Report of the Chief Planning Officer

PLANS PANEL EAST

Subject: Application 11/01241/FU – Change of use of part basement of existing ground floor shop to form 1 one bedroom studio flat at 482 Roundhay Road, Leeds, LS8 2HU

2010 / 08 / 02 A

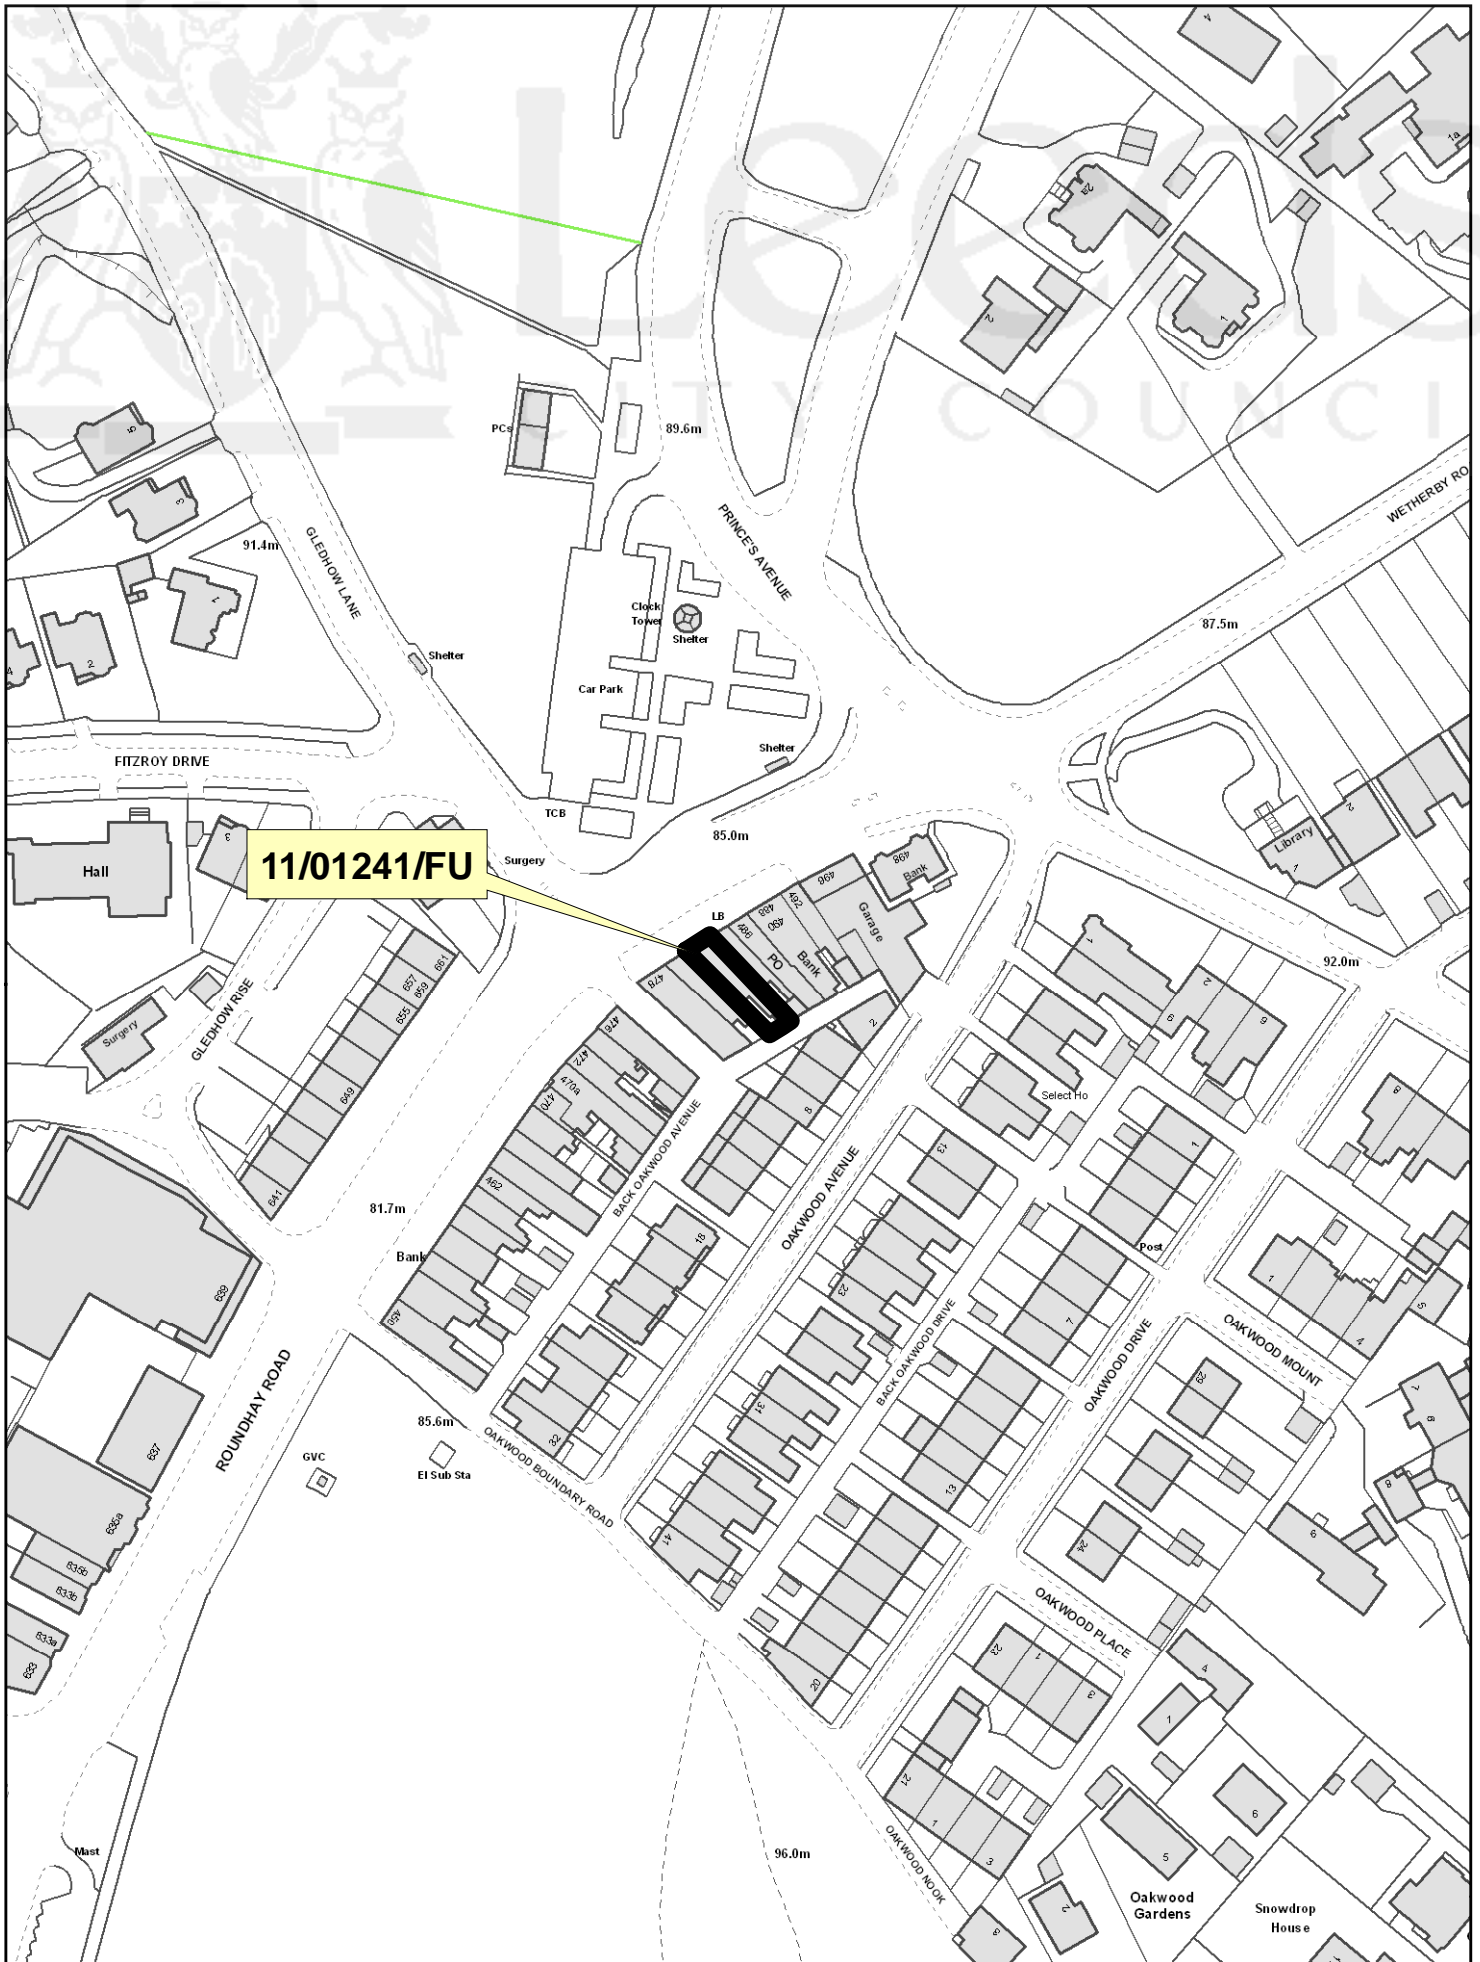
- 9.3 In terms of the lounge window in the south eastern elevation of the flat, the appeal Inspector acknowledged that that the position of this window in relation to ground levels resulted in an outlook which was better than simply the distance to the external staircase, but considered that the 'outlook is restricted by external walls and the stairs up to the ground floor flat which results in an oppressive level of enclosure such that I do not considered it to be adequate to serve this main living room.' Further excavations have now taken place to the rear of the building to enlarge the stairwell area and to increase the distance between the living room window and the staircase to 4.4m rather than the 2.4m which was previously proposed.

- 9.4 Neighbourhoods for Living recommends a minimum outlook distance of 10.5m from main aspect windows. Whilst the proposals have been revised to extend the stairwell area by a further 2m and lower the adjacent boundary wall, with the stated aim of improving the outlook and increasing natural light levels to this area, it is considered that the level of outlook from this lounge window would still be constrained as a result. Whilst it is proposed to lower the side boundary wall adjacent to the stairwell, it is considered that the sense of enclosure to this area would remain due to the height and proximity of the two storey projection to the rear of the neighbouring property, less than a metre away from the side boundary wall to the south west of the stairwell, and over 8m higher than the ground level within the stairwell area, since this projection would still appear as a dominant presence when viewed from the living room, kitchen and bedroom windows facing onto the stairwell and restrict the levels of light reaching this area due to its height and orientation to the south/south west.

- 9.5 In terms of the proposed kitchen window in the south western elevation of the flat, the appeal Inspector noted that this faces the external stairwell wall – which is also the site boundary wall – some 2.3m distant. The Inspector noted that this did not accord with the 2.5m recommended in Neighbourhoods for Living, and that whilst it provides for some daylight, it was restricted and did not allow for any significant degree of outlook. Whilst it is proposed to lower the height of the south western boundary wall and replace it with railings, the substandard separation distance would remain and, as discussed above, the outlook and natural light levels to this window would still be severely compromised by the two storey projection to the rear of the neighbouring property to the south west, which would be only 3.3m from the kitchen window to the proposed basement flat. Whilst in excess of the recommended separation distance in Neighbourhoods for Living, it is noted that the guidance in the SPG advises that the suggested distances should not simply be applied without consideration of the character of the site, and that they should be regarded as the normal minimum requirement for flat sites with conventional windows, and that for unconventional sites additional allowance is required. In view of the position of the proposed flat at a lower level in relation to surrounding land and buildings, this is not considered to be a conventional site, and it is considered appropriate to have regard to this guidance in this instance. It is not considered that the proposal to lower the boundary wall and replace it with railings would be

- 9.6 As well as the concerns discussed above relating to the outlook from the proposed flat windows, it is also considered in view of the layout of the proposed flat and the constrained outlook from the living room and kitchen windows, that the level of natural light reaching the majority of the internal part of the flat would be limited to such an extent that it would necessitate reliance on artificial lighting to these areas for the majority of the day.

- 9.7 With regard to the bedroom window in the rear elevation of the proposed flat, the Inspector noted that this high level window would give some daylight as long as the area outside the window were not blocked by a parked car or other items in the yard. The size of the external area is such that any vehicle parked within this proposed parking space would be less than a metre from the window. Whilst the Inspector noted that the site is in a sustainable location and that future occupiers may choose not to have a car, she considered that in the event that they did have a car it was likely they would park it in this space given the limited availability of parking in the locality, and therefore it was likely that the view from the bedroom window would be curtailed by a parked car. She also considered that, in any event, given the size and height of this window, it would again result in a 'rather oppressive sense of enclosure in this room.' Details submitted with the application suggest that future occupiers would have the option of using a nearby car park if they did not wish to park outside the rear of the property. However, whilst the car park in question may not be subject to any restrictions at present, its function is to provide parking for the shops and services within Oakwood local centre, and it should not be relied upon to provide parking for residential properties. In addition, it is considered in view of the distance to this public car park and the security concerns that are likely to arise from the fact that vehicles parked there would not be visible from the property, that it is much more likely that future residents who did choose to have a car would park in the space to the rear of the property. It is therefore considered that little weight can be given to this possibility.

- 9.8 Following the dismissal of the appeal, the plans for the flat have now been revised and a second window has been inserted in the side elevation of the proposed bedroom to provide an additional source of light and outlook. However, the position of this window is such that it looks directly onto the side of the relocated external staircase only 1.3m away, and the boundary wall beyond only 2.4m away, and would therefore again fall considerably short of the suggested separation/outlook distances in Neighbourhoods for Living, which recommends 7.5m between a bedroom window and a boundary. Furthermore, this second bedroom window is also located directly beneath the landing area of external staircase on the floor above, which projects out by around a metre above the window and thus further restricts the level of natural light reaching this area. As such, whilst it is noted that the addition of a second window to the proposed bedroom area may provide some additional light, any such improvement is likely to be marginal due to the position of the landing above and the restricted outlook from this window, and it is not considered that this would satisfactorily address previous concerns regarding the substandard levels of amenity in this bedroom area.
